SUBJECT : Hyundai ImageQuest Co., Ltd.
FCC ID: PJIL17A0D080
Class II Permissive Change
Orig. Grant Date: March 12, 2003

Transmitted herewith, on behalf of Hyundai ImageQuest Co., Ltd. is an application for a Class II Permissive Change Certification of the following 17-inch LCD Monitor:

FCC ID : PJIL17A0D080
Model/Type : L70S/L17A0D080

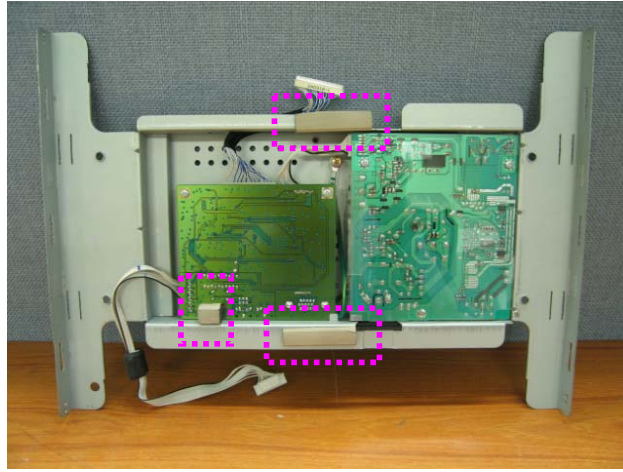
1. Attach a gasket on the main frame and main board to contact the LCD panel

2. Apply ferrite core to OSD signal line
